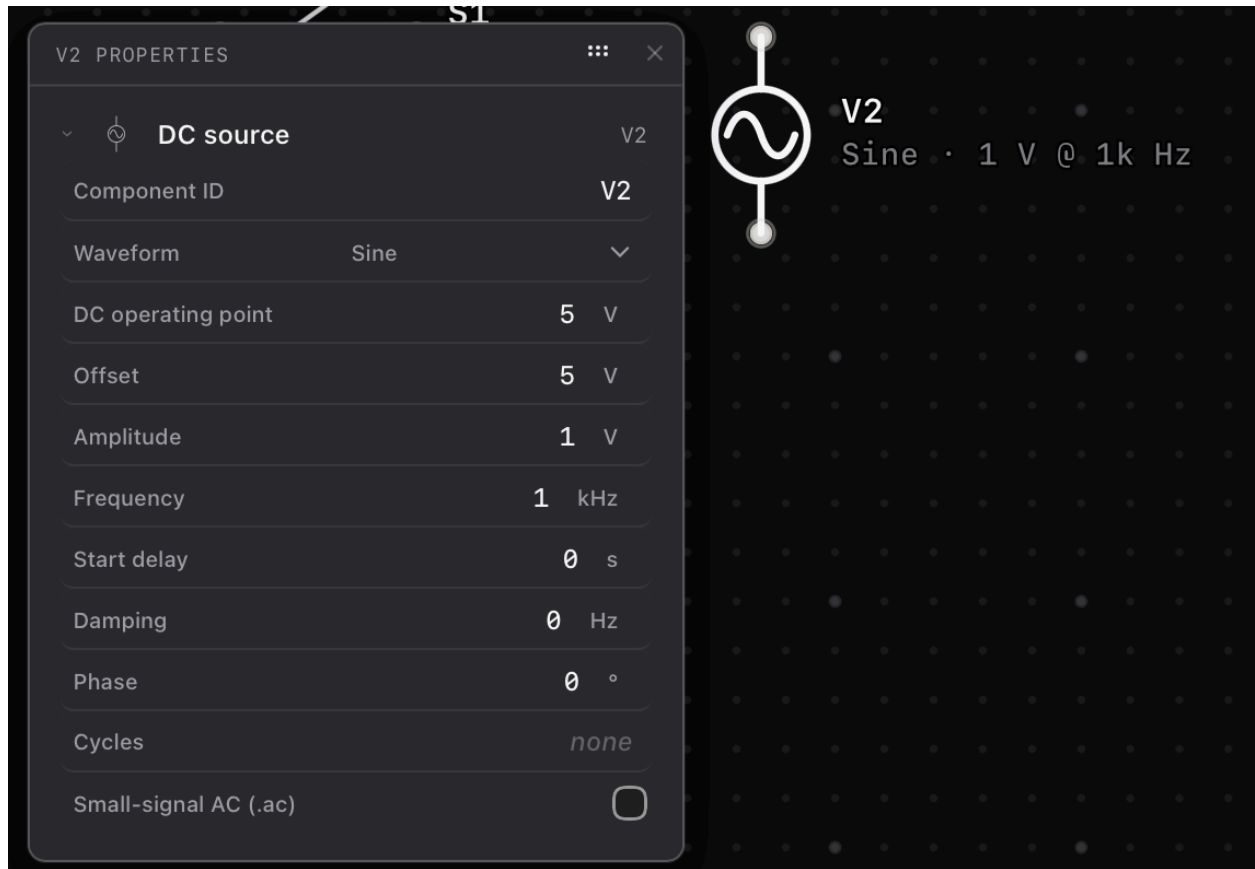
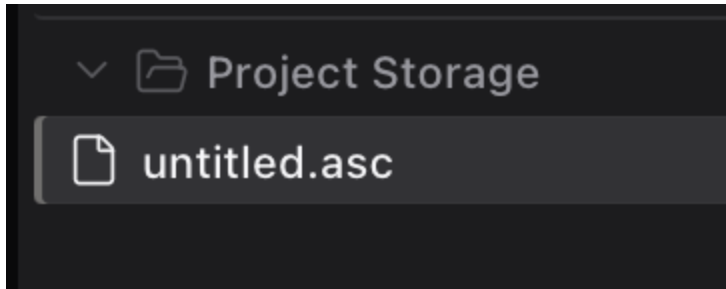
1. I believe the classification of a DC source and then having subwaveform options for voltage sources that act as a sine waves still under the category of DC source is a bad idea. I understand wanting a variety of voltage sources but the two should conflate. We should not have DC options and AC options intertwined only if it makes complete sense. If expostential is more closely related to DC then maybe but selection of it should completely swap the component to be the corresponding one.

For example I envision someone selecting a DC source. Then in the V# properties they might change their mind and want an AC signal that should replace the drawing which it already does and also replace any sign of its former self. The same should apply to the different modes. (ask follow up questions if unsure)

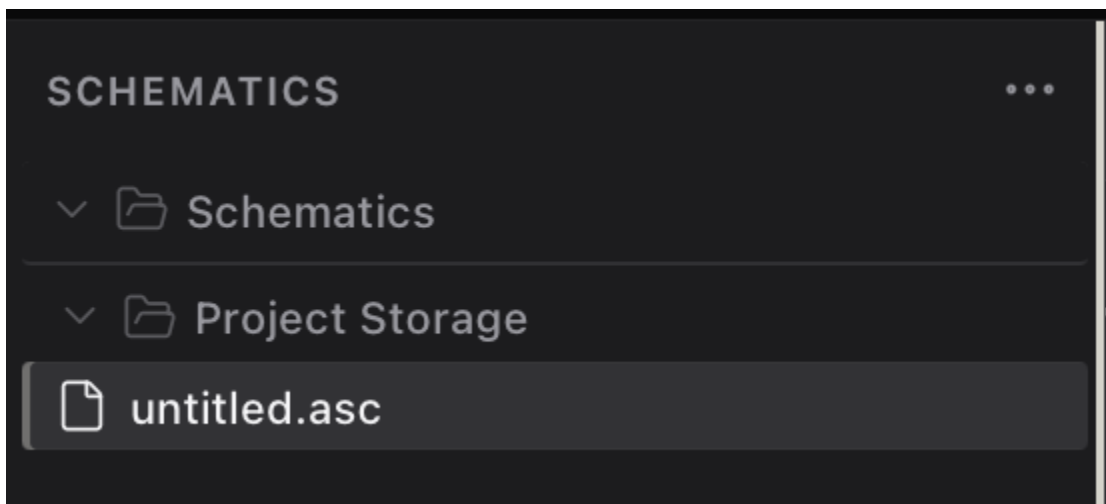
3. The LED should not have a color.

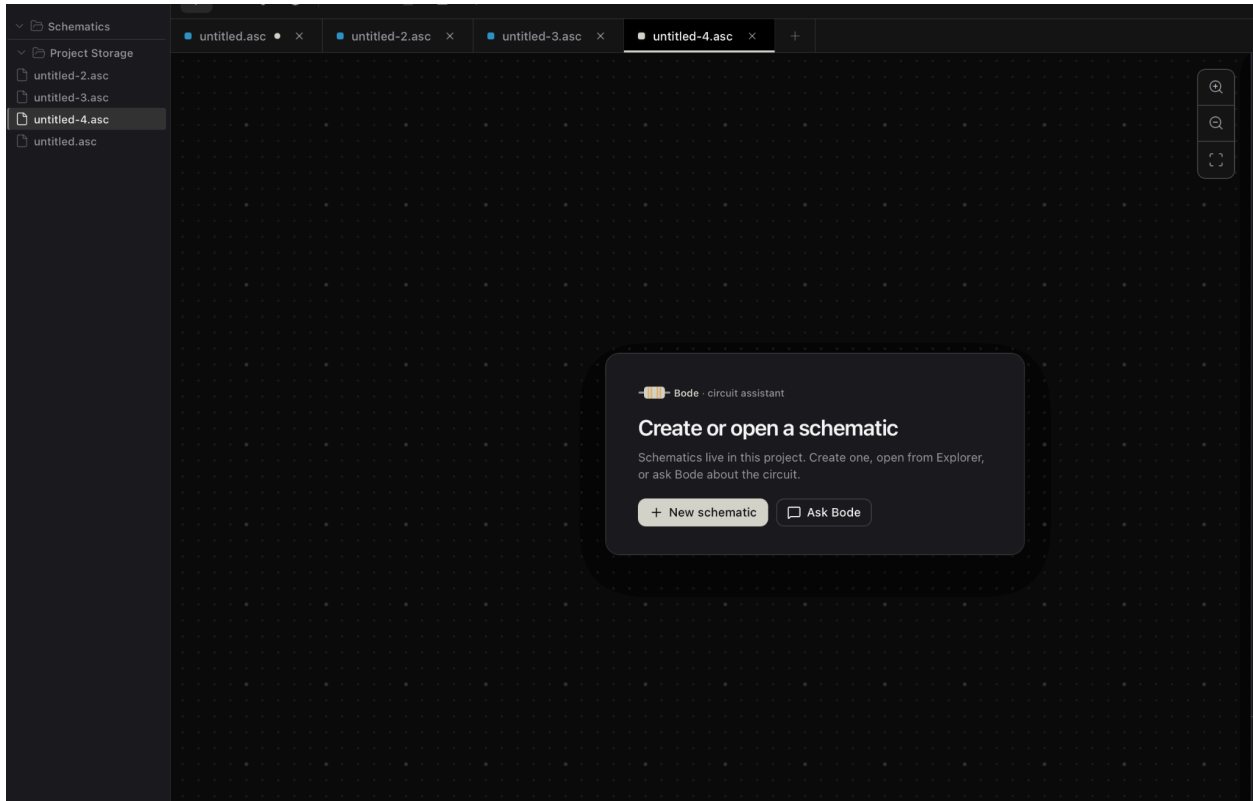
4. There is ample space to show the settings I like the current three dot approach but we should be able to see them at a smaller window size as long as it has decent space from the text of the folder name it should be able to dynamically adjust.

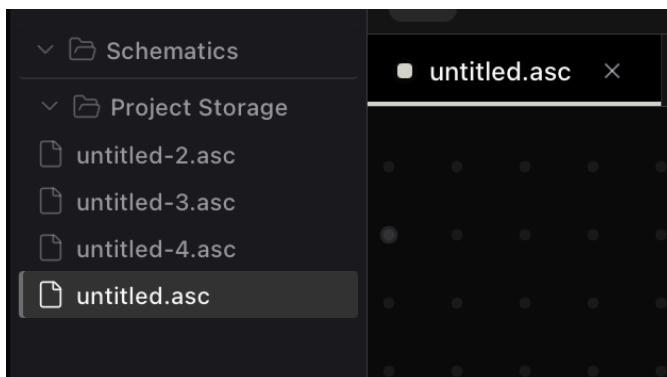
4. If we are already in an empty schematic the wording should be more of a place a component down. I imagine it highlighting or emphasizing the component library it should almost guide the user to use the components we have or you can ask Bode to create one. Change the wording on this screen.

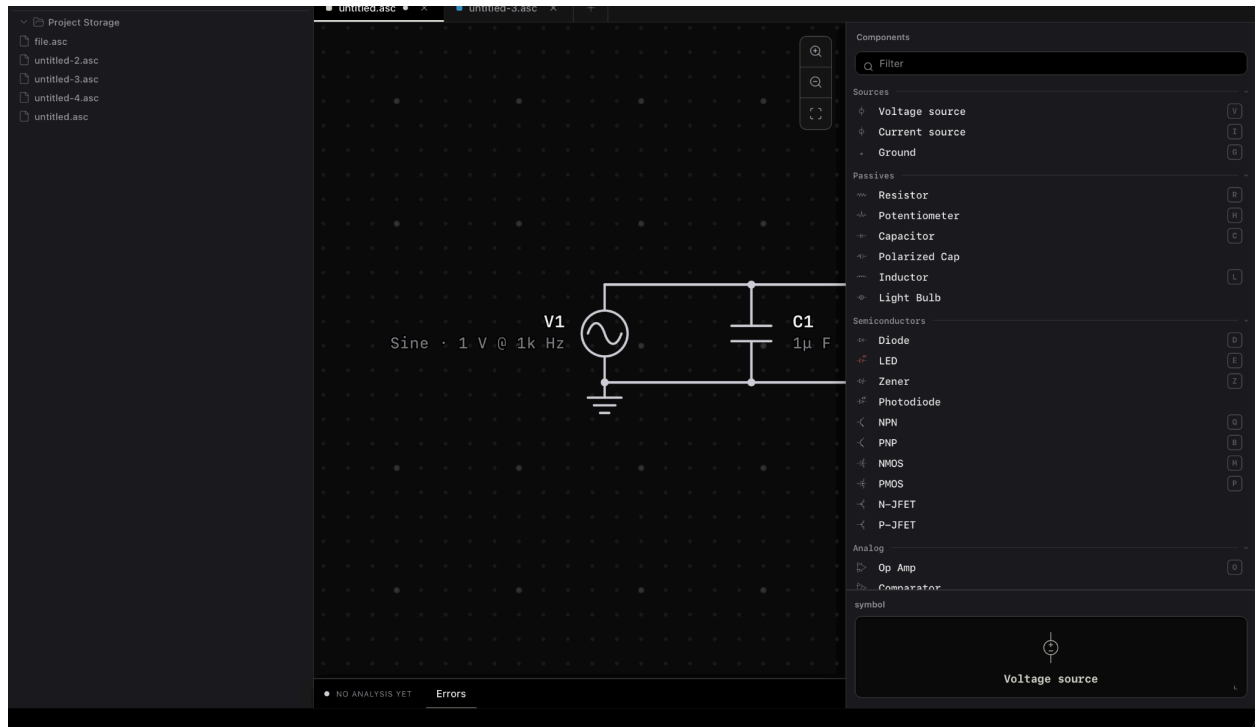
6. Id like for the files to look indented almost to denote they live within a folder

7. Absolutely no overlap between labels EVER.

8. This component should always be facing upwards the point facing up when dropped into schematic

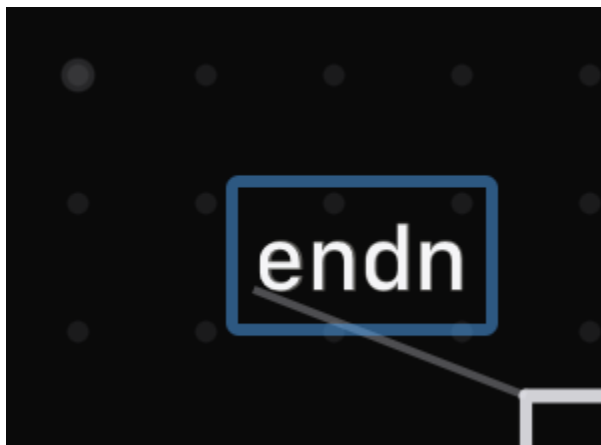
10. The autocentering button does not work. It needs to work dynamically as the user resizes each tab.

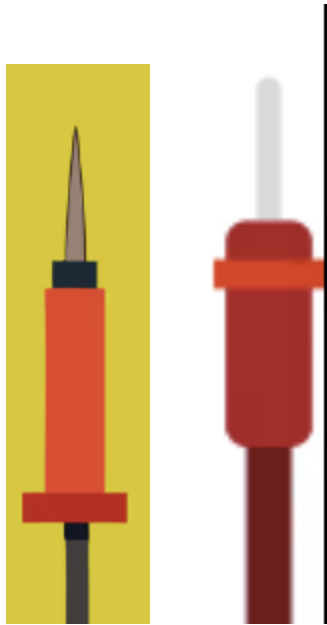
12. Replace the probe sign with a red multimeter probe something like the following:
